TELETYPEWRITERS TT-7/FG AND TT-8/FG AND
TELETYPE MODEL 19 TELETYPEWRITER SET 4.2A-1TM 11-2216
TO 31W4-2FG-131 }
CHANGES No. 3 }DEPARTMENTS OF THE ARMY
AND THE AIR FORCE
WASHINGTON 25, D. C., 5 June 1958

TM 11-2216/TO 31W4-2FG-131, 11 October 1951, is changed as indicated so that the manual also applies to the following equipment:

Change the title of the manual to: TELETYPEWRITERS TT-7/FG AND TT-8/FG AND TELETYPE MODEL 19 TELETYPEWRITER SET 4.2A-1.

Figure 128.v (Added) Rectifier REC-13, schematic diagram.

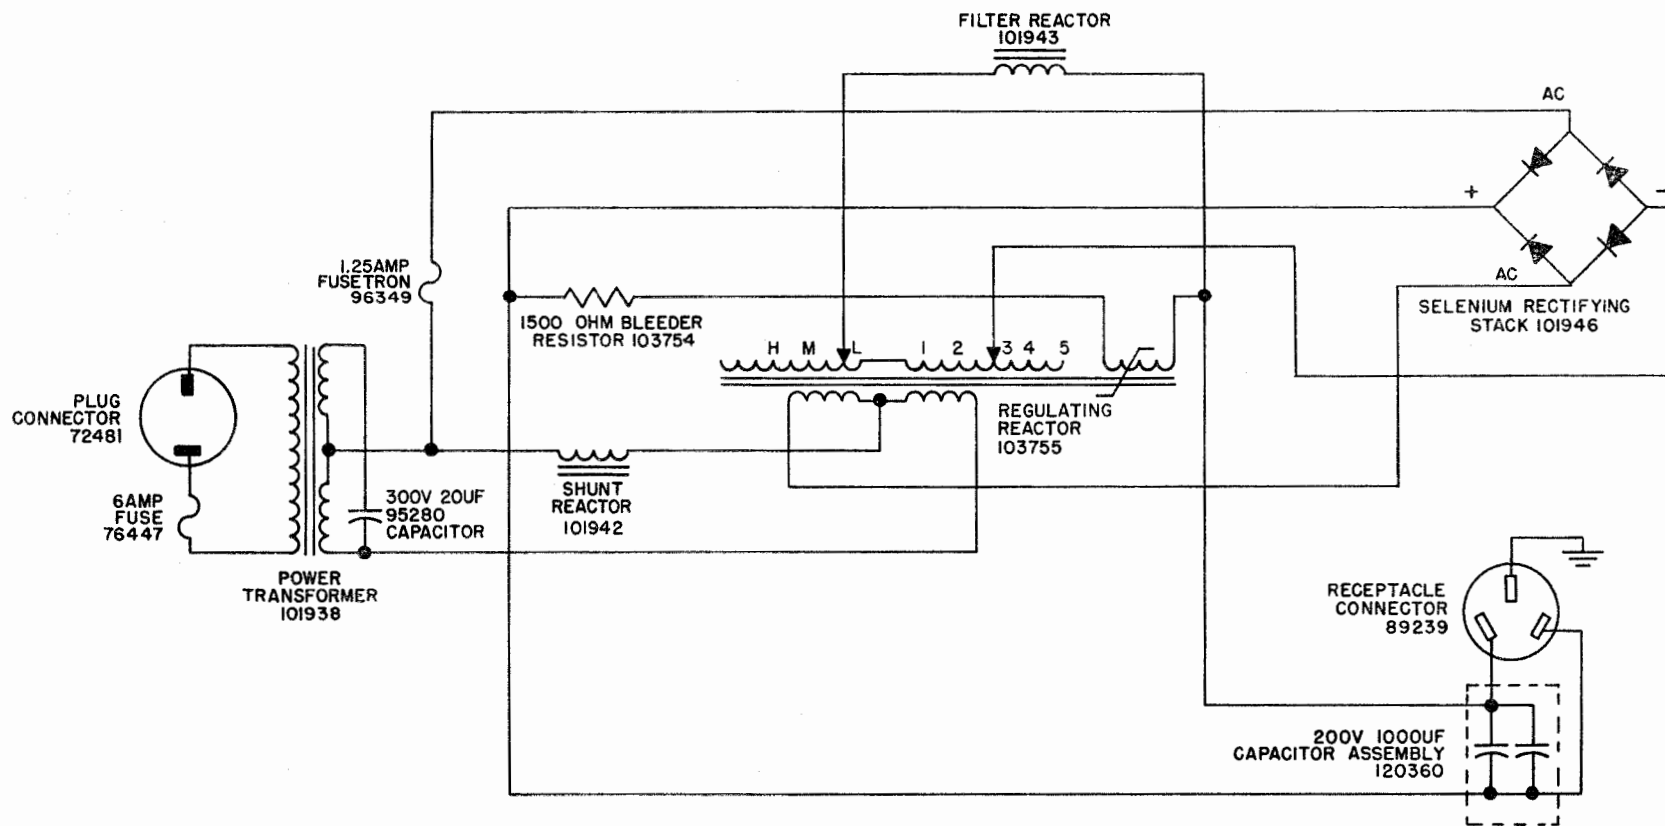
b. *Circuitry* (fig. 128.1).

(1) The ac input voltage is connected to the primary of the power transformer. The 6-amp fuse, connected in series with the ac input, protects the primary winding of the power transformer. The power transformer increases the input voltage to a voltage high enough to compensate for the

internal resistance of the rectifier. The shunt reactor and 20-uf capacitor help maintain a steady voltage in the secondary winding of the power transformer.

- (2) Two coils in the regulating reactor that are connected to the secondary winding of the power transformer and a dc coil within the regulating reactor help maintain a constant output voltage despite load variations. The voltage across the two series coils is varied by saturation of the reactor core by the current in the dc coil. When the load varies, increasing or decreasing the output voltage, the ac input to the selenium rectifying stack increases or decreases in accordance with the strength of the magnetic field set up by the dc coil in the regulating reactor. The bleeder resistor controls the current level in the dc coil to maintain the dc field under no-load conditions.

- (3) The filter reactor and 200-volt, 1,000- μ f capacitor assembly insure a low-ripple dc output. The 1.25-amp fuse-tron protects the output circuit from damage due to overload.

Figure 323.1 (Added) Motor PD-22/U (Motor MU-4), exploded view.

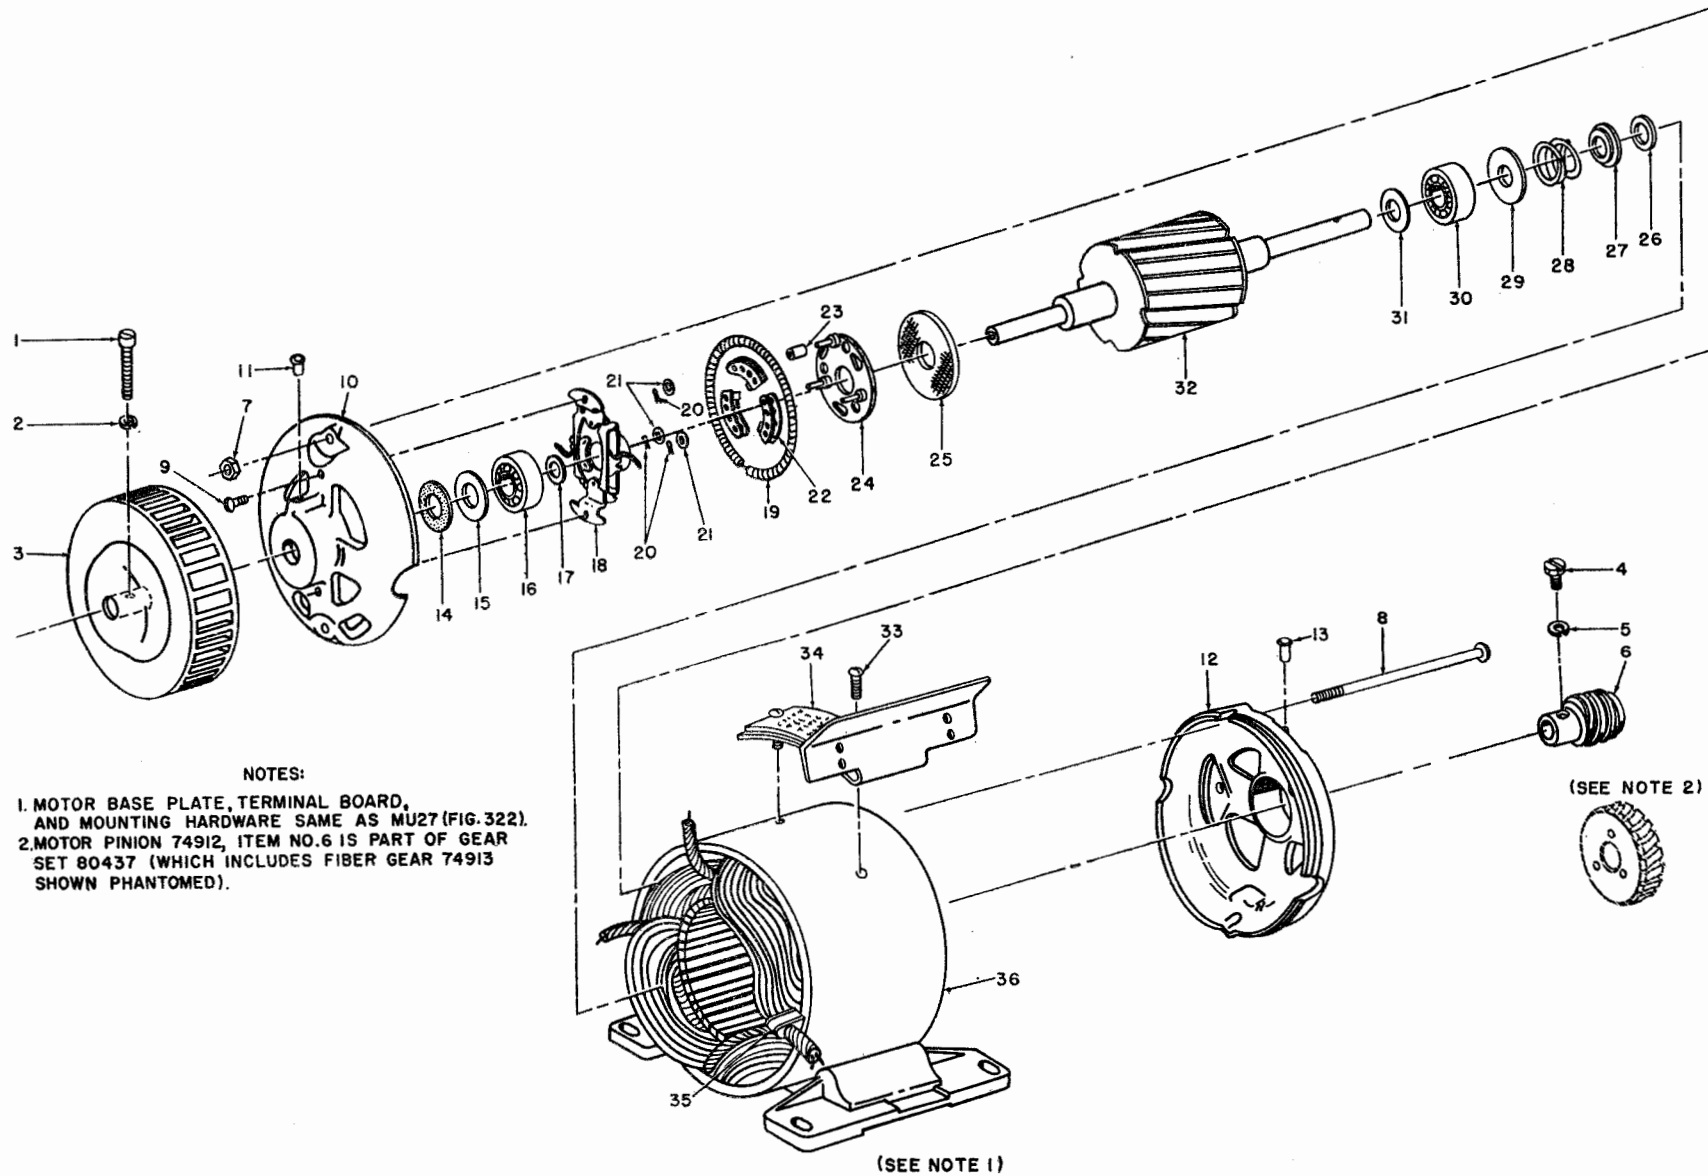
Delete the tenth and eleventh sentences and substitute: **The motor of the PU-109/GG is series-governed and requires a 110- to 120-volt, 50- to 60-cycle power source. Motor Unit PD-22/UG (formerly Motor MU-4) is furnished with Teletype Model 19 Teletypewriter Set 4.2A-1. The PD-22/UG includes a synchronous motor, attached to a base plate. The PD-22/UG requires a regulated 110-volt, 60-cycle, single-phase power source.**

Figure 325 (Superseded) Filter assemblies for cam pulsing contacts, keyboard transmitting contacts, and punch magnet contacts.

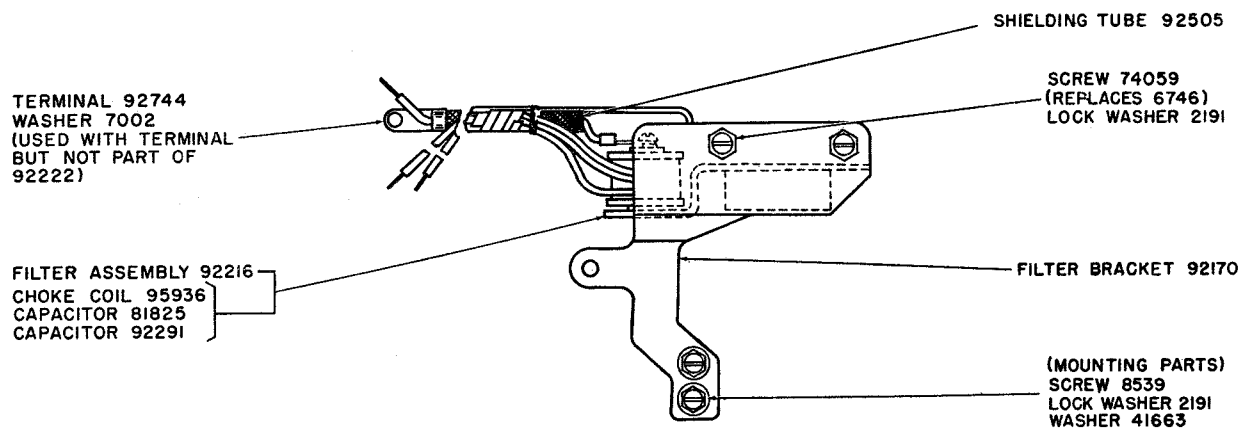
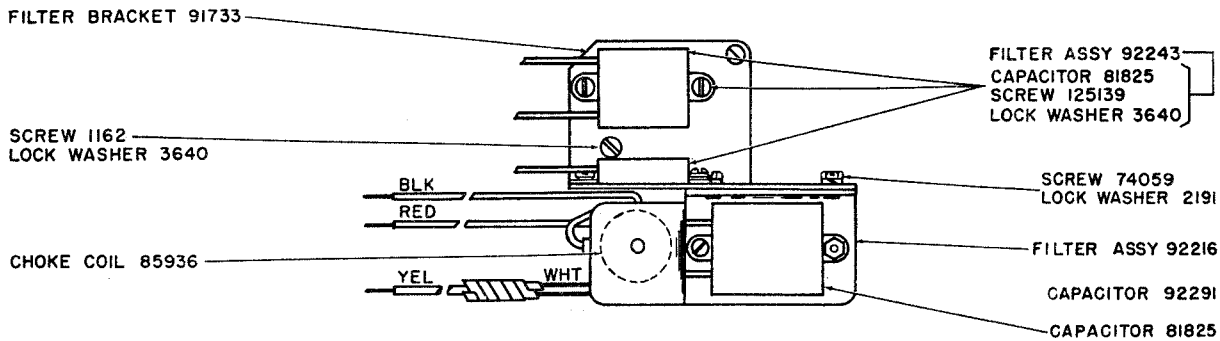
A. FILTER UNIT ASSEMBLY 92224
(CAM PULSING CONTACTS)

B. FILTER UNIT ASSEMBLY 92222
(KEYBOARD TRANSMITTING CONTACTS)
(105964 WITHOUT MOUNTING PARTS)

C. FILTER UNIT ASSEMBLY 92225
(PUNCH MAGNET) (EXCLUDES 92243)

Figure 331.1 (Added) Rectifier REC-13, parts identification.

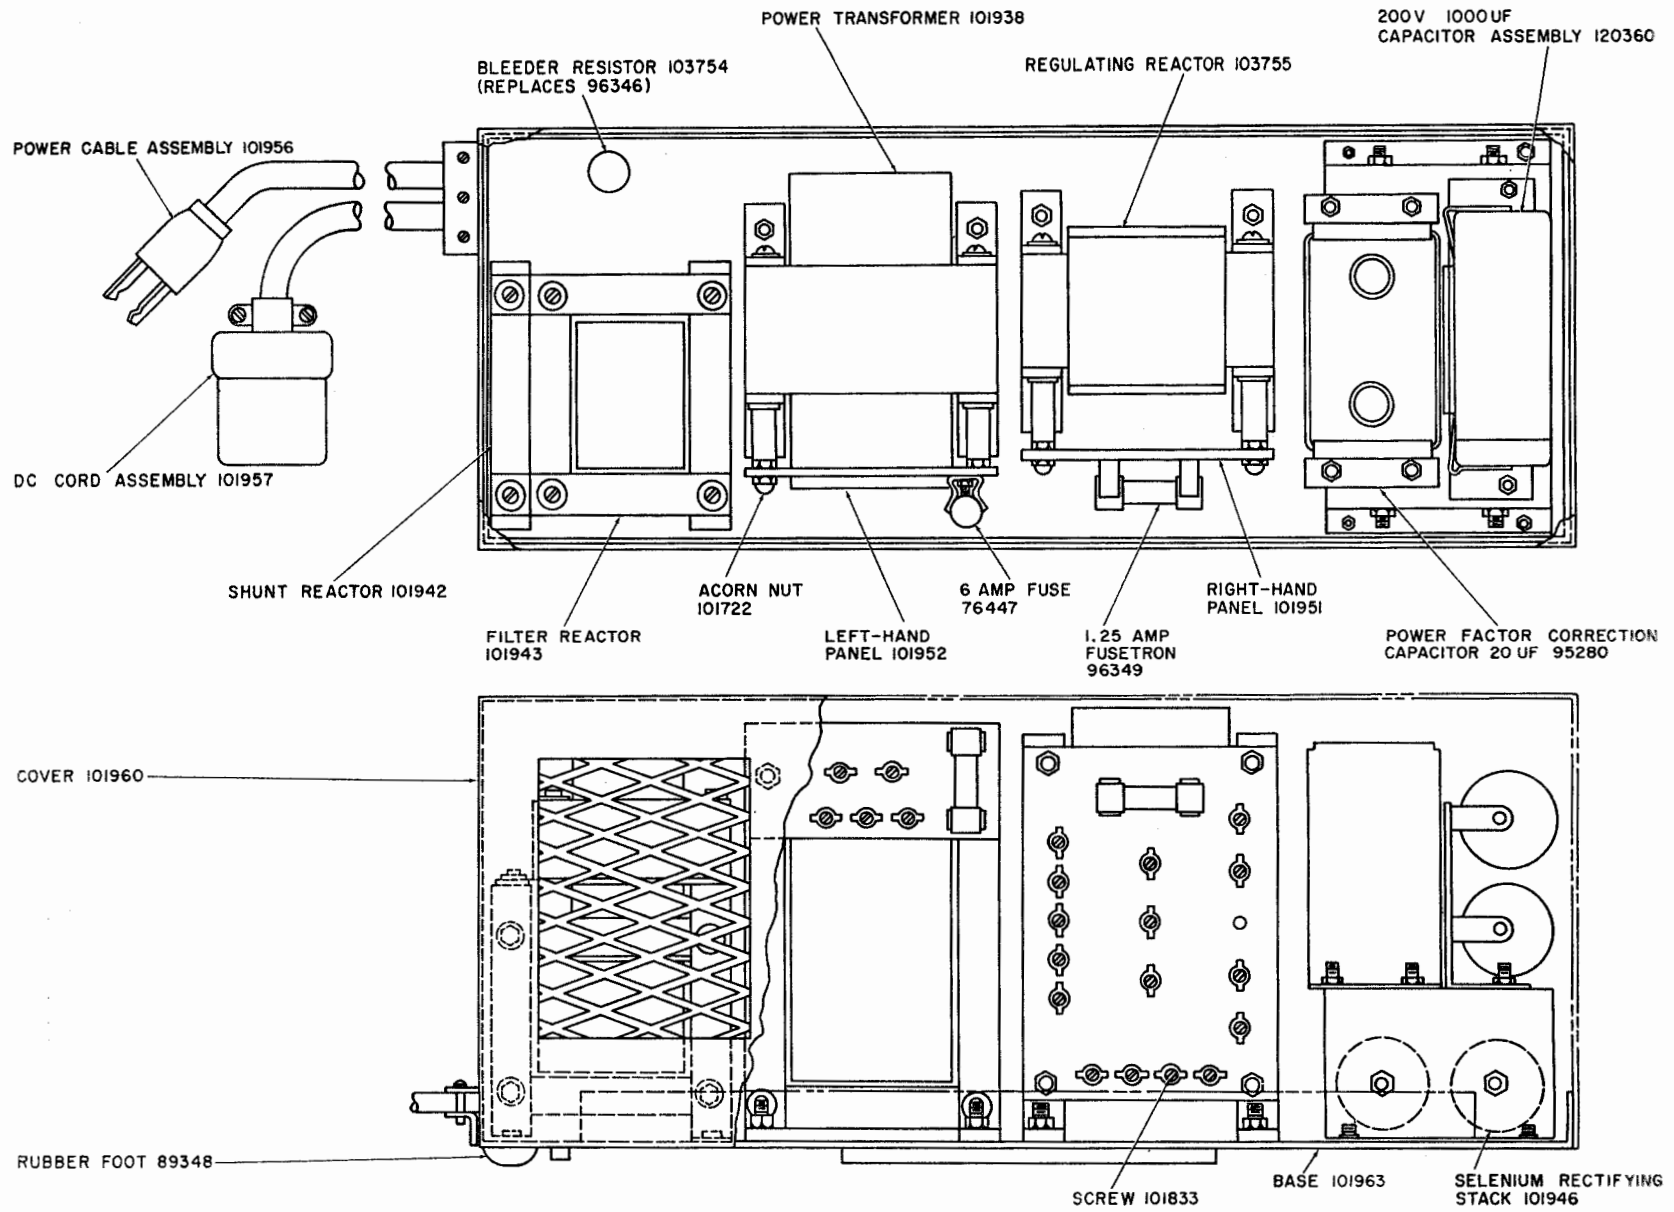
Disconnect the rectifier power cords from the table receptacles and place the rectifier on a work bench. Perform all applicable maintenance procedures described in paragraph 59. Refer to paragraph 139.1, and figures 128.1 for circuit details. If replacement of a part is required, refer to figure 331.1 for part identification information. After repair, adjust the dc output voltage (par. 490.1). If the required output cannot be obtained with this adjustment, replace the selenium rectifying stack and readjust the output voltage.

Figure 273.1 (Added) Rectifier REC-13, wiring diagram.

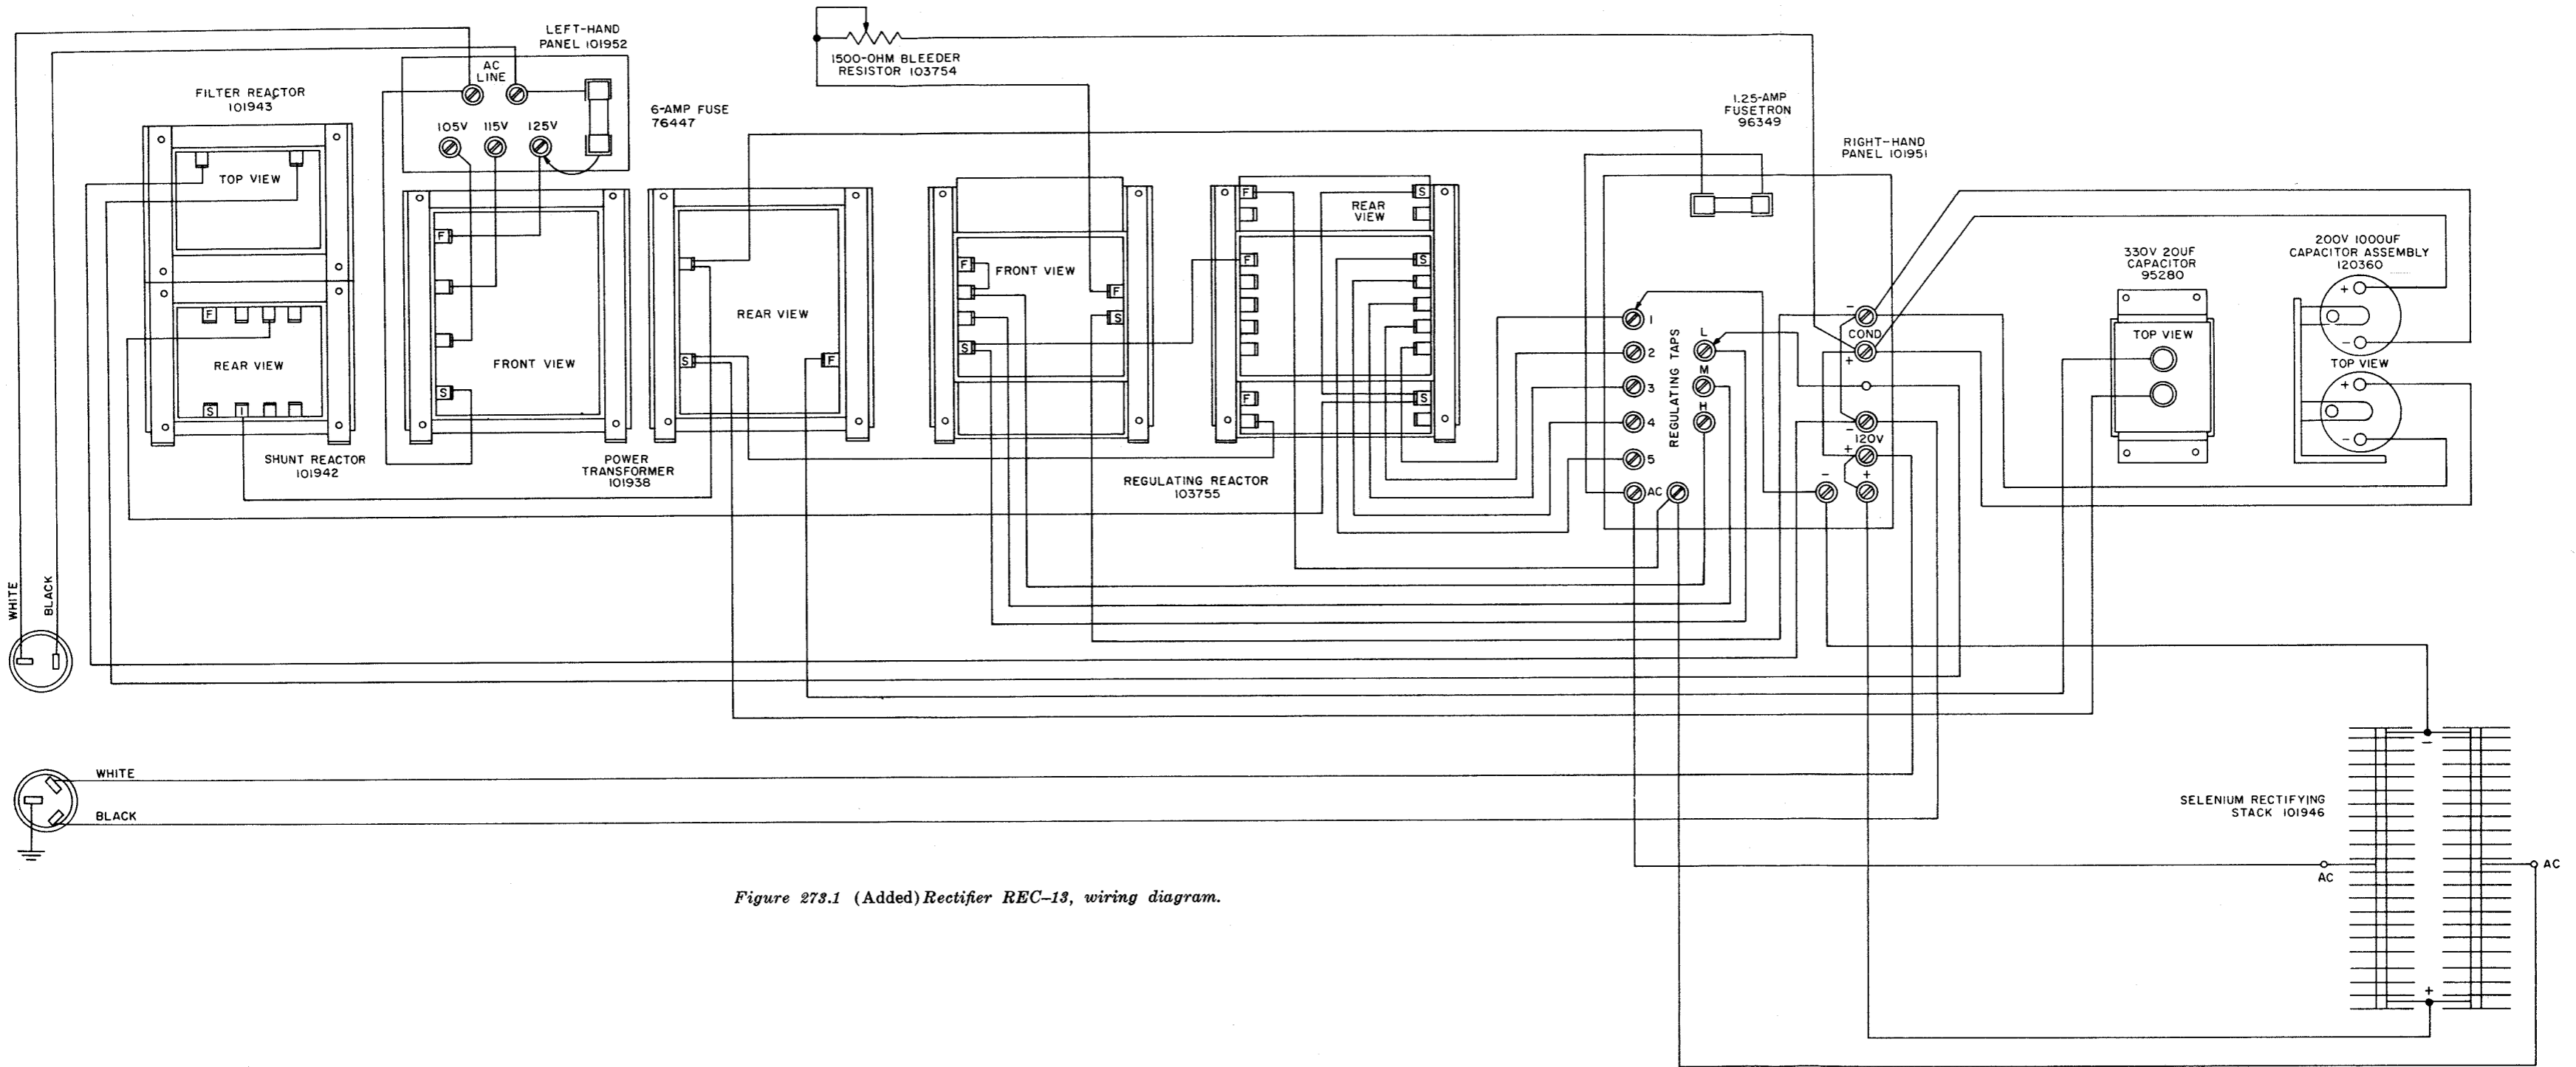
- (3) Open the door of the REC-13 and check the fuses on the left-hand (input) and right-hand (output) panels (fig. 273.1). The ac input fuse should be a 6-amp fuse and the dc output fuse should be a 1.25-amp fuse.

c. (Added) Refer to paragraph 139.1 and figure 273.1 for details of the circuits in the REC-13.
